Access Compliance Report Public Rights-of-Way (Curb Ramps)

Main Street: O_NEILL_DR Cross Street: MCGWIRE_RD Location: SW

ADA ID: RPRK211025131223 Ramp Type: Type 1 - Perpendicular Diagonal Initial Pass/Fail: Fail Overall Compliance: No Severity Score: 2

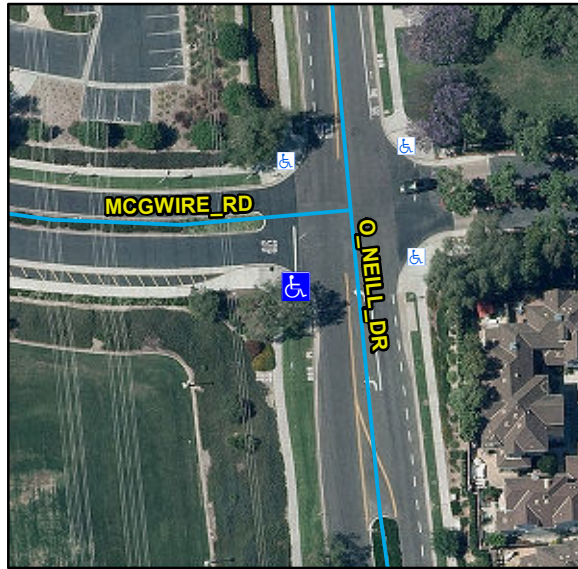
Compliance	Description	Data	Compliance	Description	Data
N/A	Ramp Length (in)	133	N/A	Flare Type LT	
Yes	Ramp Width (in)	48			N/A
Yes	Ramp Run Slope (%)	5.3	N/A	Flare Slope LT (%)	N/A
No	Ramp Cross Slope (%)	3.6	N/A	Flare Traversable LT	N/A
N/A	Landing Present	N/A	N/A	Flare Type RT	
N/A	Landing Length (in)	N/A			N/A
N/A	Landing Width (in)	N/A	N/A	Flare Slope RT (%)	N/A
N/A	Landing Run Slope (%)	N/A	N/A	Flare Traversable RT	N/A
N/A	Landing Cross Slope (%)	N/A	N/A	DWS Provided	N/A
N/A	Landing Movement Obstructed?	N/A	N/A	DWS Contrast	N/A
	Landing Movement Type	N/A	N/A	DWS Length (in)	N/A
N/A	Landing Shared	N/A	N/A	DWS Full Width	N/A
N/A	Clear Space	Yes	N/A	DWS Offset Left (in)	N/A
N/A	Clear Space To Crosswalk (in)	N/A	N/A	DWS Offset Right (in)	N/A
N/A	Marked Crosswalk 1	No	N/A	Marked Crosswalk 2	No
	Crossing 1 Direction	E		Crossing 2 Direction	N
	Marked Crosswalk 1 Width (in)	N/A		Marked Crosswalk 2 Width (in)	N/A

Remove & Replace Curb Ramp With Two New Directional Ramps or Equivalent.
